### HISTORIC AND DESIGN REVIEW COMMISSION

HDRC CASE NO: 2021-053 ADDRESS: 311 MUNCEY

OWNER: Anthony Chen/ROCHA CYNTHIA A & LARRALDE ALEJANDRO G
TYPE OF WORK: Construction of a rear addition, exterior modifications, fenestration

FRONT & RIGHT
ELEVATIONS

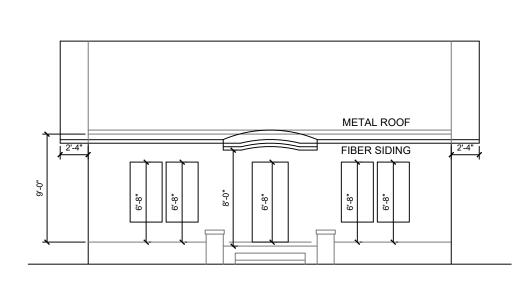
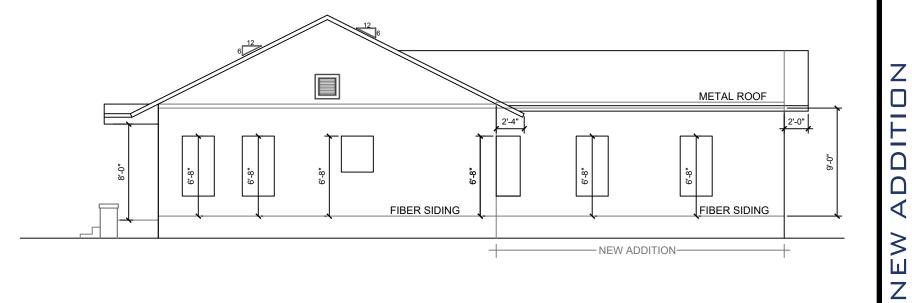
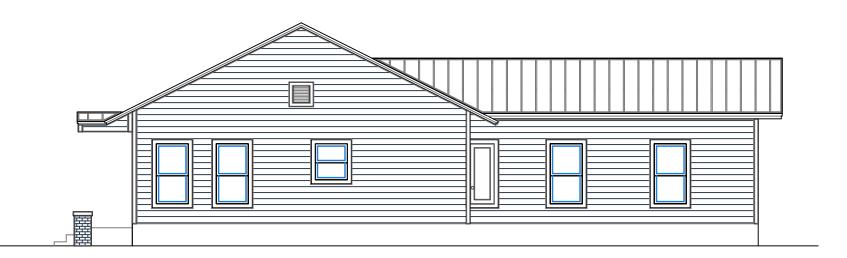
- b. REAR ADDITION The Guidelines for Additions note that additions should be sited to the side or rear of the historic structure, should be designed in keeping with the historic context of the block, should feature a similar roof form and should feature a transition between the historic structure and new addition. Additionally, the Guidelines note that additions should not feature a footprint so large as to double the historic structure's footprint. Generally, the proposed addition is consistent with the Guidelines; however, staff finds that the applicant should ensure a visual break is present on the right (north) elevation to separate the addition from the new construction.

- e. ARCHITECTURAL DETAILS Per the Guidelines, additions should incorporate architectural details that are in keeping with the architectural style of the original structure. Details should be simple in design and compliment the character of the original structure. Architectural details that are more ornate or elaborate than those found on the original structure should not be used to avoid drawing undue attention to the addition. Generally, the proposed addition is consistent with the Guidelines.

- 1. Staff recommends approval of the construction of a rear addition based on findings a through e with the following stipulations:
  - i. That the applicant ensure that the proposed wood windows be installed in a manner that matches the installation depth and profile of the historic structure, and that the proposed standing seam metal roof feature panels that are 18 to 21 inches in width, seams that are 1 to 2 inches in height, a crimped ridge seam, and a standard galvalume finish.
